**PLANNING APPROVAL,
PLANNED UNIT DEVELOPMENT &
SUBDIVISION STAFF REPORT**

<u>NAME</u>	Pleasant View Baptist Church
<u>DEVELOPMENT NAME</u>	Pleasant View Baptist Church Subdivision
<u>LOCATION</u>	1517 Katye Street (West side of Katye Street, 120'± South of Bank Avenue, extending to the East side of Ruby Street, 190'± South of Bank Avenue)
<u>PRESENT ZONING</u>	R-1, Single-Family Residential
<u>AREA OF PROPERTY</u>	1.6± Acres
<u>CONTEMPLATED USE</u>	Expansion of an existing church for paved parking and storage
<u>TIME SCHEDULE FOR DEVELOPMENT</u>	Immediately
<u>ENGINEERING COMMENTS</u>	Must comply with all stormwater and flood control ordinances. Any work performed in the right of way will require a right of way permit.
<u>TRAFFIC ENGINEERING COMMENTS</u>	Driveway number, size, location, and design to be approved by Traffic Engineering and conform to AASHTO standards. Sign and mark all one- way traffic flows according to MUTCD standards.
<u>URBAN FORESTRY COMMENTS</u>	Property to be developed in compliance with state and local laws that pertain to tree preservation and protection on both city and private properties (State Act 61-929 and City Code Chapters 57 and 64).

SITE PLAN

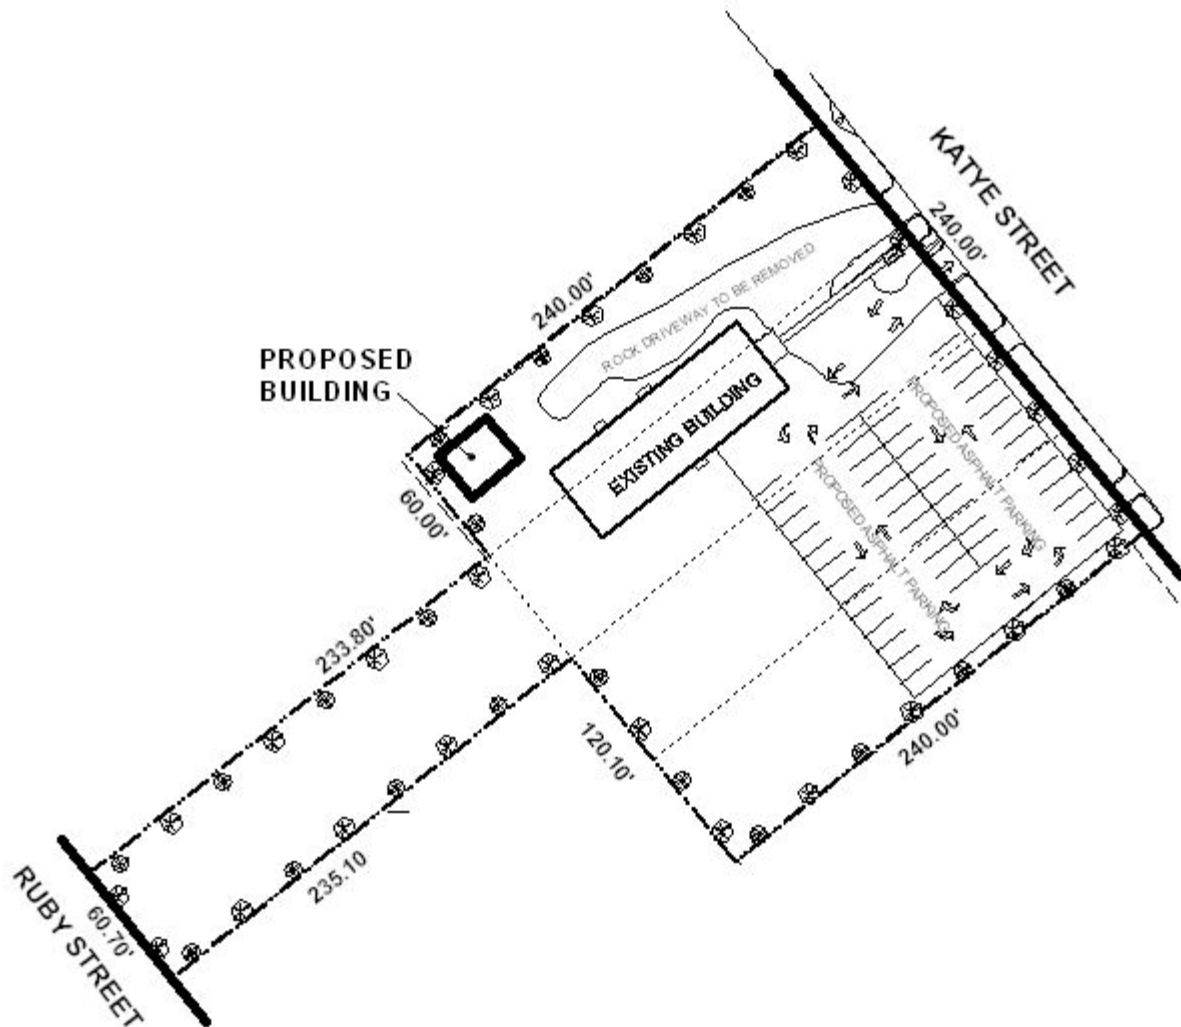
The surrounding area is predominately residential and includes a community center and another church. With the provision of a buffer, in compliance with Section IV.D.1. the new paved parking should actually serve as improvement to the area as gravel parking tends to shift and spill onto the adjoining properties and streets. The addition of the new parking area and storage building would necessitate full compliance with the landscaping and tree planting requirements of the Ordinance. Furthermore, as the parking area would be across the street from residential development, screening of the parking with a three-foot high fence or wall should be required. Additionally, all unused curb cuts should be closed, curbed, back-filled and sodded.

The PUD is required for the secondary building, which will be used for storage and possibly to park the church van. It should be noted that if a vehicle is parked in the structure, a paved drive leading to the structure would be required. Additionally, as outlined in the Traffic Engineering Comments, all traffic flows should be signed and marked.

The Subdivision application would simply consolidate multiple lots into one lot. The site plan indicates that there is 23.1 feet of right-of-way from the centerline of Katye Street to the site; a standard width right-of-way provides 25-feet from the centerline to private property. Therefore, the dedication of the necessary right-of-way to provide 25-feet from the centerline of Katye Street should be required. Additionally, as required by the Subdivision Regulations, a sidewalk should be provided along all street frontages.

Subdivision The plat meets the minimum requirements of the Subdivision Regulations and is recommended for Tentative Approval subject to the following condition: 1) the dedication of the necessary right-of-way to provide 25-feet from the centerline of Katye Street.
